BUILDING ENVELOPE CONDITION REVIEW **YEAR 1**

CARLYLE AT VICTORIA HILL
280 ROSS DRIVE
NEW WESTMINSTER, BC

PREPARED FOR:
ONNI CUSTOMER RELATIONS
ATTENTION: RACHEL LEVENSTON

MAY 17, 2011

Photo 2.1.1: Horizontal cracks at the valley of the concrete eyebrow at the elevator stairwell roof with efflorescence staining below.

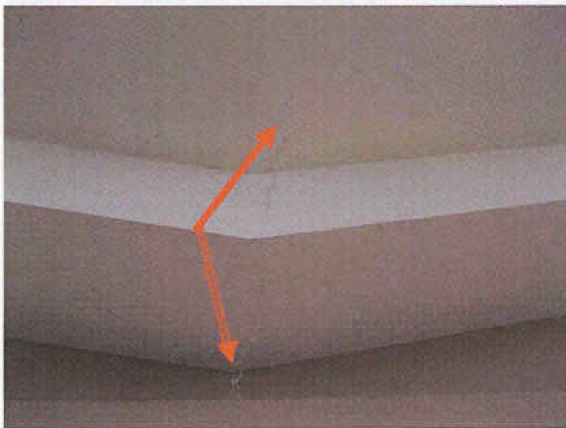
- Some minor cracking was observed at concrete building walls and eyebrow locations, but is to be expected due to building settlement.
- Where reviewed, minor efflorescence staining was observed at the concrete walls, planter curbs, architectural pillars, balcony soffits, and the main roof eyebrows.

- .1 *Recommendation:* Patch any cracks in the concrete as they occur. The crack should be routed out, cleaned, and sealed with a polyurethane sealant. Any cracks in excess of 1/16" (width) should be reviewed by a Structural Engineer.

- .2 *Recommendation:* Review concrete walls, planter curbs, architectural pillars, balcony soffits, and the main roof eyebrows to determine all locations where efflorescence stains are occurring and have a qualified contractor make repairs as required.
